Seabrook Station

License Amendment Request 14-04

Revised Reactor Coolant System Pressure - Temperature Limits Applicable for 55 Effective Full Power Years

NextEra Energy Seabrook's Evaluation of the Proposed Change

Figure 1: WCAP-17441 P-T Limits drawn on Comparison of Seabrook WCAP-15745 P-T Limits to Inlet Nozzle Limits [the superimposed red line is the 55 EFY 100° F/hr curve]

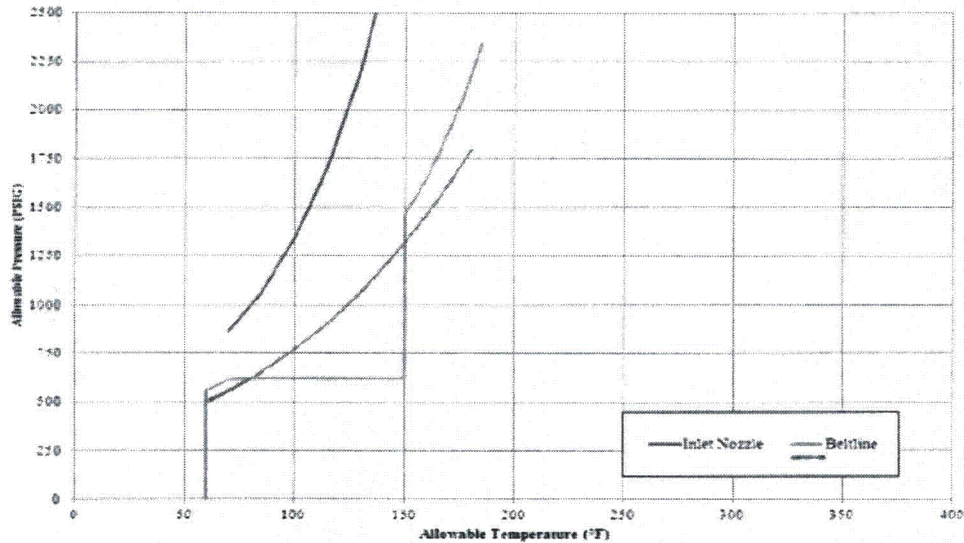
NextEra's response to the NRC's request for additional information (RAI) [Reference 5] supporting Seabrook Amendment 135 [Reference 6] discussed that WCAP-14040-A did not consider the inlet/outlet nozzles and demonstrated that the P/T limit curves are bounding for the entire reactor pressure vessel (RPV) by the development of component specific P/T limit curves for the RPV inlet/outlet nozzles. Figures 1 and 2 provided in the RAI response compared the nozzle P/T limits to the beltline P/T limits derived in WCAP-15745. The component specific P/T limit curves for the inlet and outlet nozzles that supported the RAI response as well as the proposed 55 EFPY P/T limits

were developed using 55 EFY fluence. Utilizing the data provided in Table 6-4 of WCAP-17441-NP, the P/T limits derived in WCAP-17441-NP for the most limiting 100° F/hr cooldown case have been superimposed on those figures below and demonstrate that the beltline P/T limits derived for 55 EFY are below and to the right of the nozzle curves and remain bounding.

FIGURE 3.4-2
REACTOR COOLANT SYSTEM HEATUP LIMITATIONS - APPLICABLE UP TO 23.7 EFPY

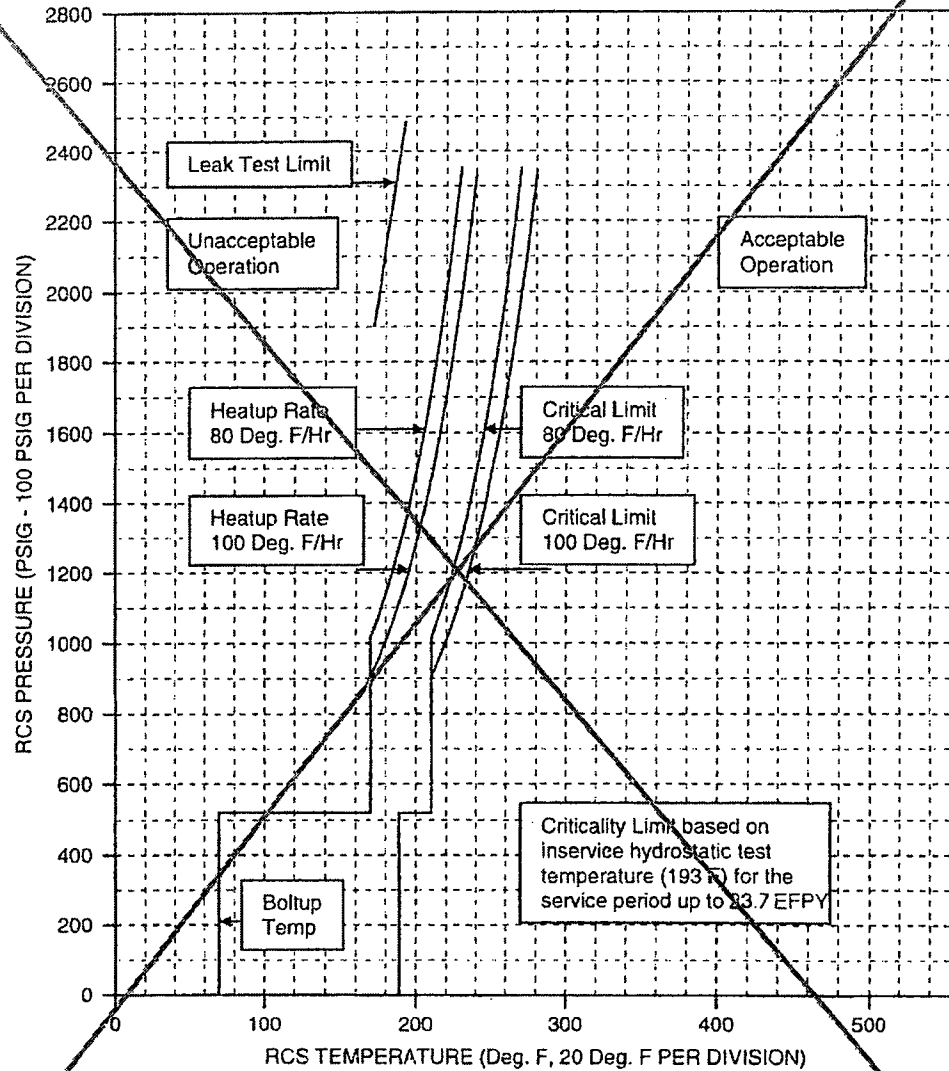
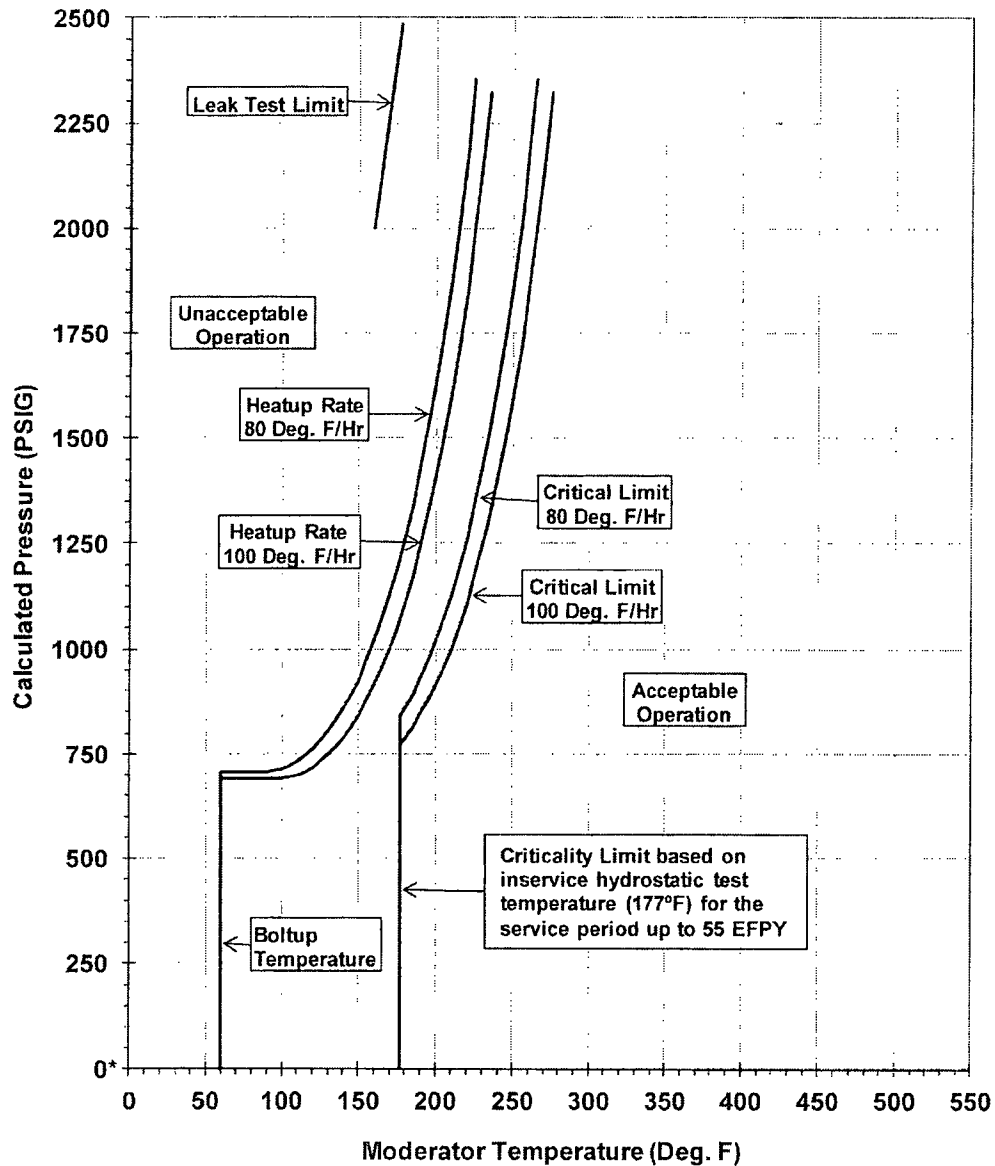
- Figure 3.4-2, Reactor Coolant System Heatup Limitations - Applicable Up to 23.7 EFPY, is replaced with a new figure applicable to 55 EFPY.
- Figure 3.4-3, Reactor Coolant System Cooldown Limitations - Applicable Up to 23.7 EFPY, is replaced with a new figure applicable to 55 EFPY.

Replace this Figure and
information with the Figure and
information on the following page

MATERIAL PROPERTY BASIS

Limiting material: LOWER SHELL PLATE R1808-1 WITHOUT USING SURVEILLANCE DATA, POSITION 1.1

Limiting ART values at 55 EFPY: 1/4T, 117°F (Axial Flaw)

3/4T, 105°F (Axial Flaw)

Curves applicable for the first 55 EFPY and do not contain margins for possible instrument errors

* Curve is applicable during RCS vacuum fill

REACTOR COOLANT SYSTEM HEATUP LIMITATIONS – APPLICABLE UP TO 55 EFPY

FIGURE 3.4-3
REACTOR COOLANT SYSTEM COOLDOWN LIMITATIONS - APPLICABLE UP TO 23.7 EFY

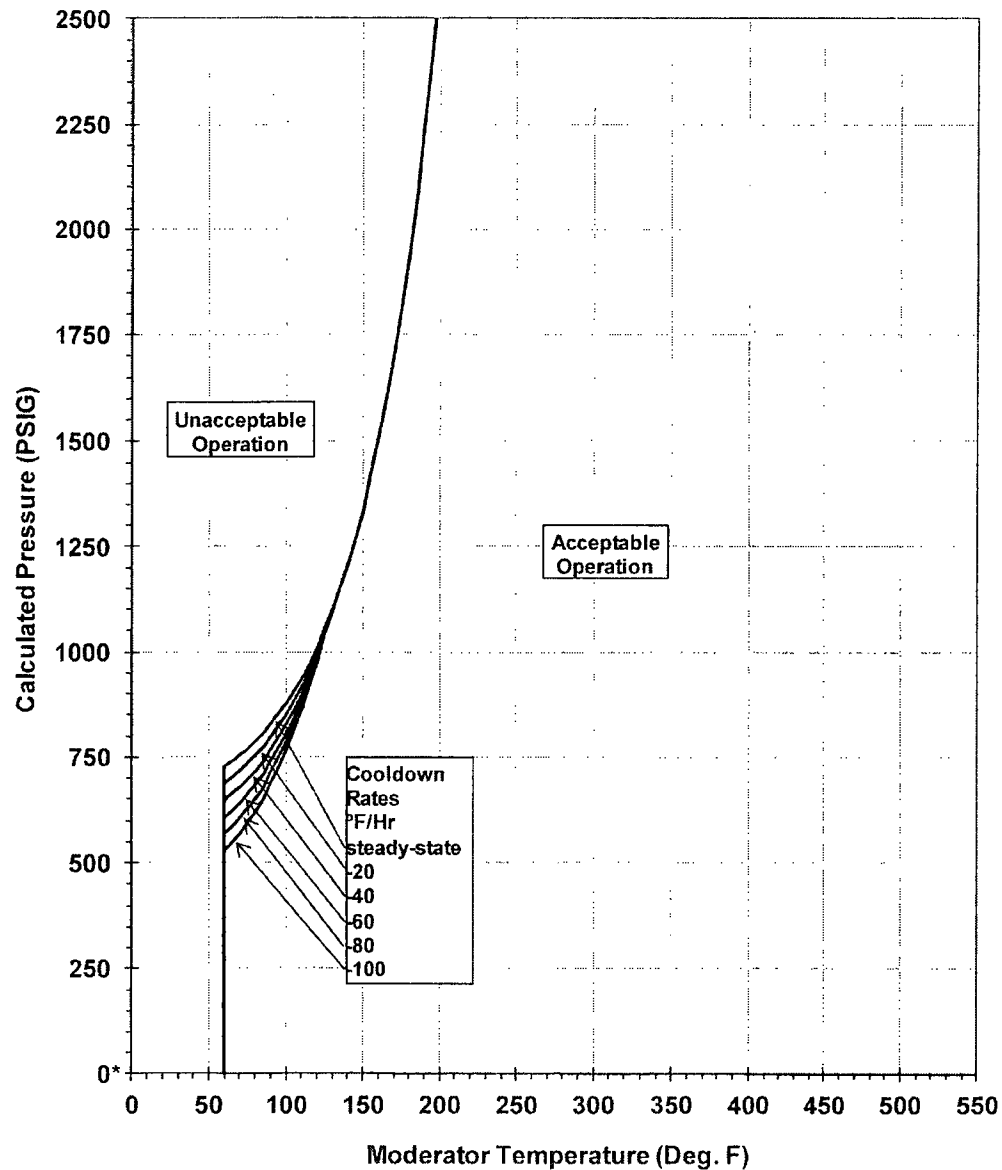
Replace this Figure and
information with the Figure and
information on the following
page.

MATERIAL PROPERTY BASIS

Limiting material: LOWER SHELL PLATE R1808-1 WITHOUT USING SURVEILLANCE DATA, POSITION 1.1

Limiting ART values at 55 EFPY: 1/4T, 117°F (Axial Flaw)

3/4T, 105°F (Axial Flaw)

Curves applicable for the first 55 EFPY and do not contain margins for possible instrument errors

* Curve is applicable for RCS vacuum fill

REACTOR COOLANT SYSTEM COOLDOWN LIMITATIONS – APPLICABLE UP TO 55 EFPY

FIGURE 3.4-4 RCS COLD OVERPRESSURE PROTECTION SETPOINTS

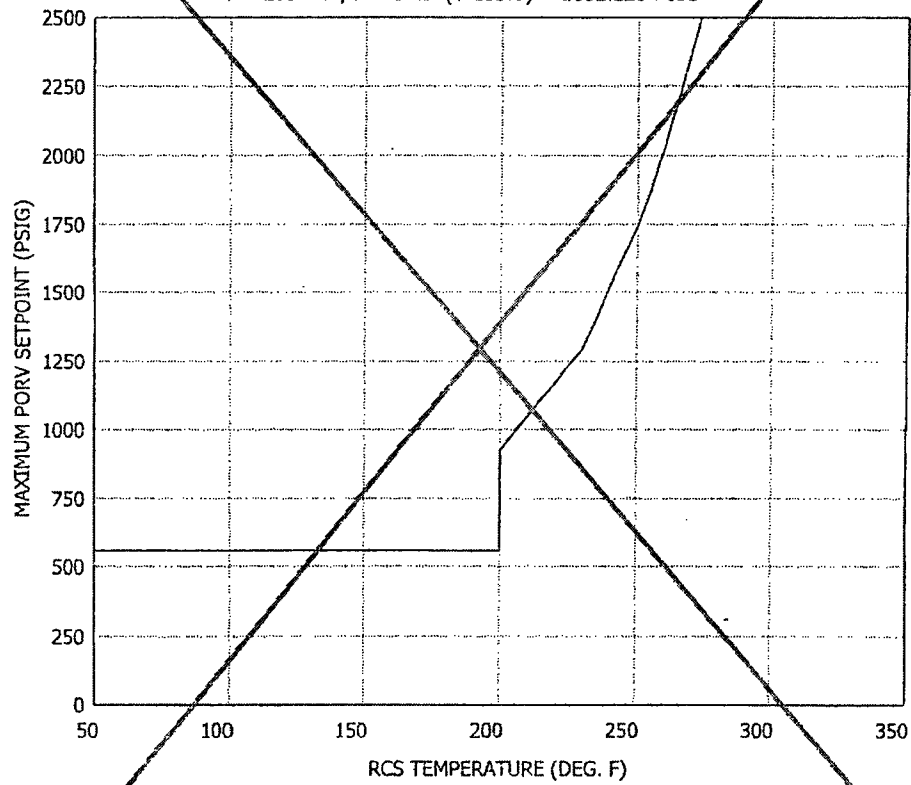
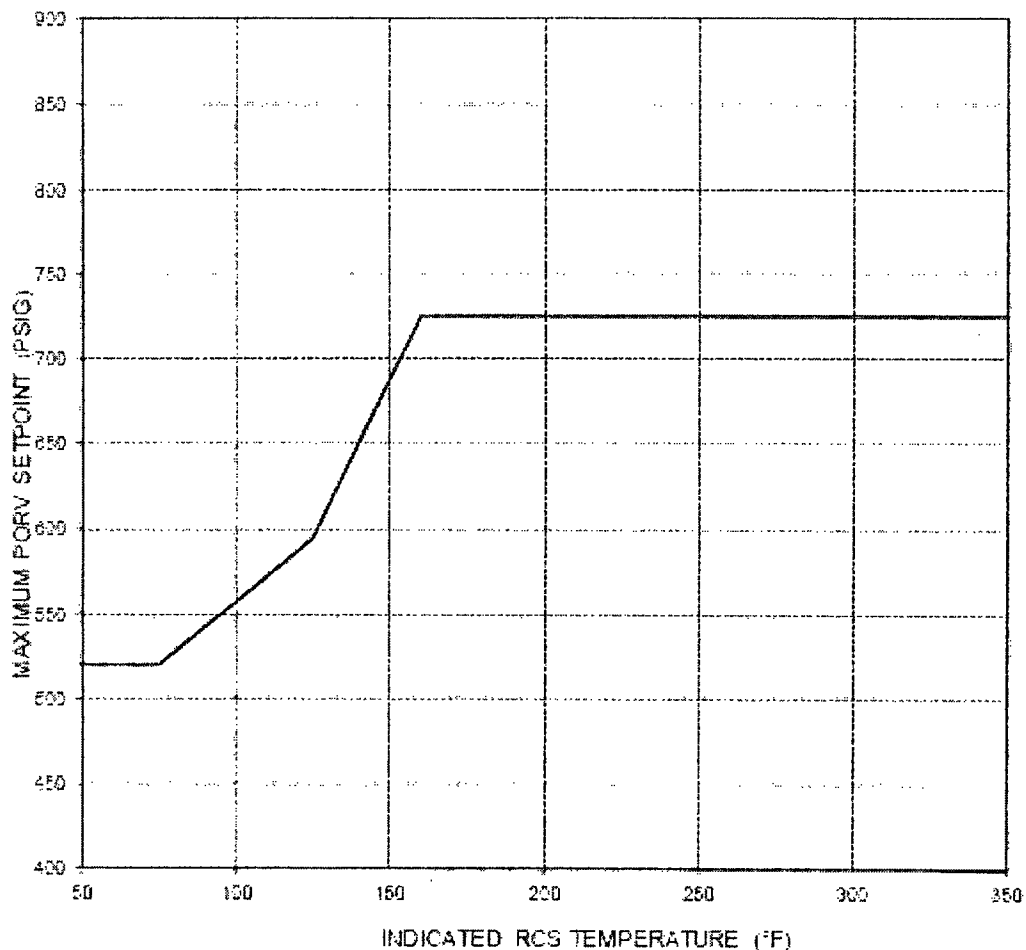
Based on the proposed P/T limit curve changes discussed above, new PORV setpoints were developed. As such, the proposed changes include a new TS Figure 3.4-4 applicable up to 55 EFPY to replace the current TS Figure 3.4-4 (applicable up to 23.7 EFPY). The proposed new TS Figure 3.4-4 is provided in Attachment 1.

Replace this figure and
information with the Figure and
information on the following page

VALID FOR THE FIRST 55 EFPY, MAXIMUM SETPOINT ACCOUNTS FOR INSTRUMENT
UNCERTAINTIES

$$\begin{aligned} T &\leq 75.0^{\circ}\text{F}, P = 520.0 \text{ PSIG}; \\ 75.0^{\circ}\text{F} < T &\leq 125.0^{\circ}\text{F}, P = 1.5(T - 75.0) + 520.0 \text{ PSIG}; \\ 125.0^{\circ}\text{F} < T &\leq 160.0^{\circ}\text{F}, P = 3.71(T - 125.0) + 595.0 \text{ PSIG}; \\ 160.0^{\circ}\text{F} < T &\leq 350.0^{\circ}\text{F}, P = 725.0 \text{ PSIG} * \end{aligned}$$

FIGURE 3.4-4 MAXIMUM ALLOWABLE PORV SETPOINTS FOR COLD OVERPRESSURE
PROTECTION SYSTEM
